<b>AMENDMENT OF SOLICITATION/MODIFICATION OF CONTRACT</b>				1. CONTRACT ID CODE	PAGE 1 OF 2 PAGES
2. AMENDMENT/MODIFICATION NO. AMENDMENT NO. 0002		3. EFFECTIVE DATE 08-30-10	4. REQUISITION/PURCHASE REQ. NO.	5. PROJECT NO. (If applicable) 09-0093	
6. ISSUED BY CODE ltc  Officer in Charge of Construction MCI-East 1005 Michael Road Camp Lejeune, NC 28547-2521			7. ADMINISTERED BY (If other than Item 6) CODE  See Item 6		
8. NAME AND ADDRESS OF CONTRACTOR (No., street, county, State and ZIP Code)				(X)	9A. AMENDMENT OF SOLICITATION NO.  N40085-09-R-0093
				X	9B. DATED (SEE ITEM 11)  08-20-10
					10A. MODIFICATION OF CONTRACT/ORDER NO.
					10B. DATED (SEE ITEM 11)
CODE		FACILITY CODE

Project 09-0093 Upgrade & Replace Fire Alarm Systems, Various Buildings

DATE: <b>7/30/2010</b>	<b>FINAL SUBMISSION</b>	<b>E1.53</b>
FACILITY ENGINEERING DEPT DWG NO.		DEPT OF NAVY <b>MARINE CORPS BASE, CAMP LEJEUNE, N.C.</b> PUBLIC WORKS DIVISION
DES: OAS	UPGRADE AND REPLACE FIRE ALARM SYSTEMS, VARIOUS BUILDINGS	
DR: MCW	BUILDING NO. 780 FIRST FLOOR	
CHK: EJM	FIRE ALARM SYSTEM	
SUPV: JWM	NAVJG DRAWING NO. 60006413	
IN CH:	APPROVED: FEO OR OICC	DATE
SATISFACTORY TO	DATE	SCALE NOTED) SPEC: 09-0093

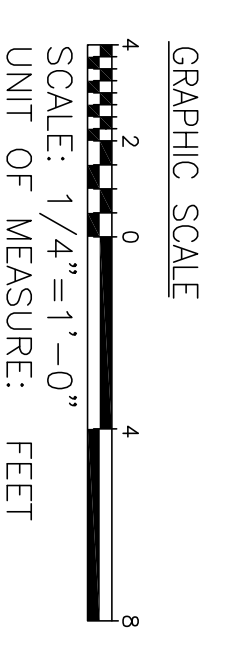
Question: Drawing E1.53 Building 700 appears to be blank. Will a drawing be provided for this building?

Answer: Incorporate attached drawing E1.53.
